# UNITED STATES PATENT AND TRADEMARK OFFICE

APPLICATION NO.	FILING DATE	FIRST NAMED INVENTOR	ATTORNEY DOCKET NO.	CONFIRMATION NO.
10/549,394	10/17/2005	Kazuaki Tsuji	03039PCT	1632
23165	7590	08/02/2006	EXAMINER	
ROBERT J JACOBSON PA 650 BRIMHALL STREET SOUTH ST PAUL, MN 551161511				LEE, GILBERT Y
			ART UNIT	PAPER NUMBER
			3673

<b>Office Action Summary</b>	Application No.	Applicant(s)
	10/549,394	TSUJI ET AL.
	Examiner	Art Unit
	Gilbert Y. Lee	3673

## **DETAILED ACTION**

Fig. 2

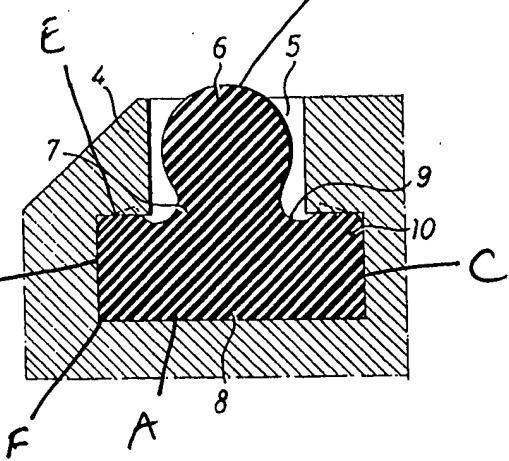
Regarding claim 6, the Engstrom reference discloses a sealing material (Col. 2, Line 8) for an ant groove (5), which is fitted to the ant groove made in a surface of either one of members in a joint place (11, 12) between these members and contacts with a surface of the other member (Fig. 3), thereby sealing both the members, with the sealing material comprising:

a sectional shape (Fig. 2) having a straight bottom edge (A) which is disposed on a bottom face of said ant groove (Fig. 2); an arched convex edge (B) which contacts

with the surface of said other member facing said ant groove (Fig. 3); a first projecting edge (C) which connects with one end of said bottom edge and projects outside (Fig. 2); a concave inlet portion (9) which is located between said first projecting edge and said arched convex edge (Fig. 2); a second projecting edge (D) which connects with the other end of said straight bottom edge and is composed of straight lines that project outside (Fig. 2); a straight sloping edge (E) of which one end connects with the opposite end of said arched convex edge as to said first projecting edge and of which the other end connects with said second projecting edge (Fig. 2); and at least one corner portion (F) which is constituted in the range of from said straight bottom edge via said second projecting edge to said sloping edge (Fig. 2);

wherein: when the sealing material for the ant groove is fitted to said ant groove, said concave inlet portion is disposed on an opening edge of the ant groove (Fig. 2), and the sealing material for the ant groove gets pressed into the ant groove (Fig. 2).

Note that the English equivalents to the patents described in the specification recite that the groove is an annular groove and has been treated as such for the examination of this application. Also note that the straight slope is connected to the arched convex edge through a concave portion (Fig. 2) and the sealing material is capable of gyrating.

FIG. 3

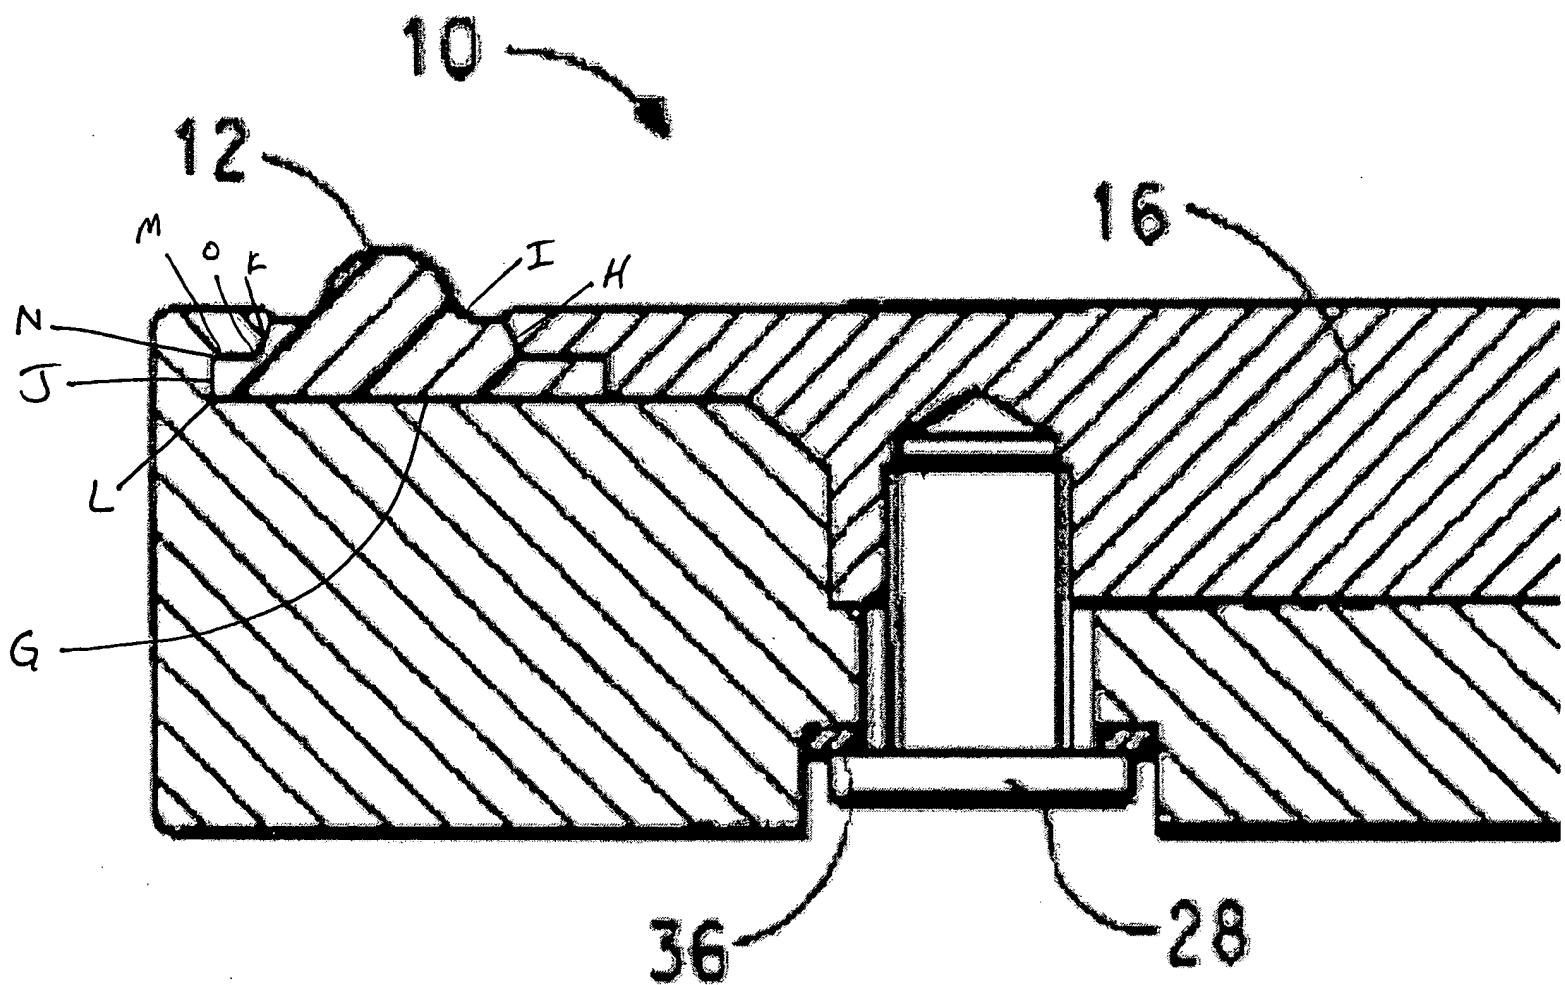
an elastically deformable material (Col. 1, Lines 35-36); and  
a sectional shape (Fig. 3) having a straight bottom edge (G) which is disposed on a bottom face of said ant groove (Fig. 3); an arched convex edge (12) which contacts with the surface of said other member facing said ant groove (Fig. 3); a first projecting edge (H) which connects with one end of said bottom edge and projects outside (Fig. 3); a concave inlet portion (I) which is located between said first projecting edge and said arched convex edge (Fig. 3); a second projecting edge (e.g. J and M) which connects with the other end of said straight bottom edge and is composed of straight lines that project outside (Fig. 3); a straight sloping edge (K) of which one end connects with the opposite end of said arched convex edge as to said first projecting edge and of which the other end connects with said second projecting edge (Fig. 3); and at least one corner portion (e.g. L) which is constituted in the range of from said straight bottom edge via said second projecting edge to said sloping edge (Fig. 3)

wherein: when the sealing material for the ant groove is fitted to said ant groove, said concave inlet portion is disposed on an opening edge of the ant groove (Fig. 3), and the sealing material for the ant groove gets pressed into the ant groove (Col. 2, lines 30-37). Note that the English equivalents to the patents described in the specification recite that the groove is an annular groove and has been treated as such

for the examination of this application. Also note that the straight slope is connected to the arched convex edge through a concave portion and horizontal edge (Fig. 3).

Regarding claim 8, the Kane et al. reference discloses said second projecting edge being formed by connecting a pair of straight edges (J and M) together in a triangular shape; and

said corner portion being constituted in the following three places: a place between said straight bottom edge and said second projecting edge (L); a crooked place of said second projecting edge (N); and a place between said second projecting edge and said sloping edge (O).
